Access Compliance Report

Public Rights-of-Way

(Curb Ramps)

Intersection ID: 13908	Main Street: BAY_ST	Cross Street: ST_JULIEN_ST	Location: W
ADA ID: DE27508DA1F7	Ramp Type: PerpDiag	Initial Pass/Fail: Fail	Overall Compliance: No
Severity Score: 25			
Codes/Mitigation Info/Possible Solution		Field Measurements/Component Compliance

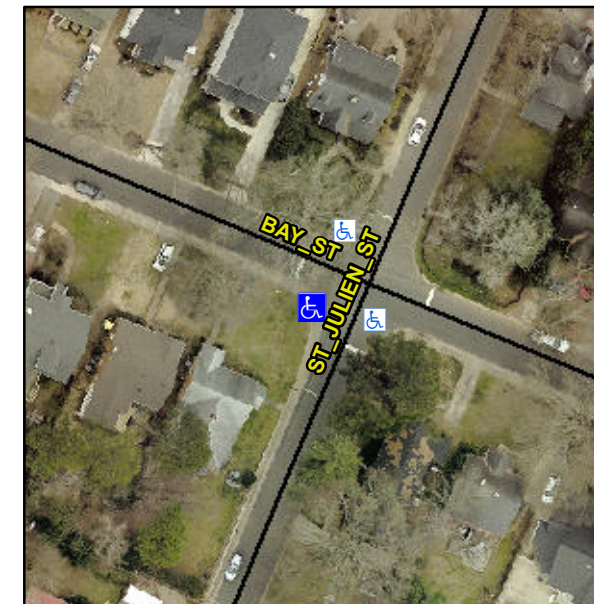
Not Found, R304.5.3

Compliance	Description	Data	Compliance	Description	Data
N/A	Ramp Length (in)	60.0	Yes	Ramp Slope (%)	5.4
Yes	Ramp Width (in)	127.0	No	Ramp XSlope (%)	7.2
N/A	Flare Type LT	N/A	N/A	Flare Type RT	N/A
N/A	Flare Slope LT (%)	N/A	N/A	Flare Slope RT (%)	N/A
N/A	Flare Traversable LT?	N/A	N/A	Flare Traversable RT?	N/A
N/A	Landing Length (in)	N/A	N/A	DWS Provided?	N/A
N/A	Landing Width (in)	N/A	N/A	DWS Contrast?	N/A
N/A	Landing Slope (%)	N/A	N/A	DWS Length (in)	N/A
N/A	Landing X Slope (%)	N/A	N/A	DWS Full Width?	N/A
N/A	Landing Curb? (Y/N)	N/A	N/A	DWS Offset (in)	N/A
N/A	Shared Landing?	N/A			
N/A	Gutter Ponding?	N/A	N/A	Gutter Slope (%)	N/A
N/A	Gutter Lip Ht (in)	0.5	N/A	Gutter X Slope (%)	N/A
N/A	Painted X Walk1?	No	N/A	Painted X Walk2?	No
	X Walk 1 Direction	To SE		X Walk 2 Direction	To NE
N/A	X Walk 1 Width (in)	N/A	N/A	X Walk 2 Width (in)	N/A
	X Walk 1 Slope (%)	4.4		X Walk 2 Slope (%)	5.5
	X Walk 1 X Slope (%)	4.0		X Walk 2 X Slope (%)	1.5

N/A	Ramp inside XWalk1?	N/A	N/A	Ramp inside XWalk2?	N/A
	Road Slope (%)	1.8	N/A	Clear Space?	N/A
	Road X Slope (%)	5.0	N/A	Clear Space to XWalk (in)	N/A
N/A	Any Obstructions?	N/A	N/A	Storm Grate/Utility Hazard?	N/A
	Obstruction Type			Storm Grate/Utility Type	
		N/A			N/A
		Yes		Surface Condition? (G/P)	Good

Remove & Replace Curb Ramp With Two New Directional Ramps or Equivalent.
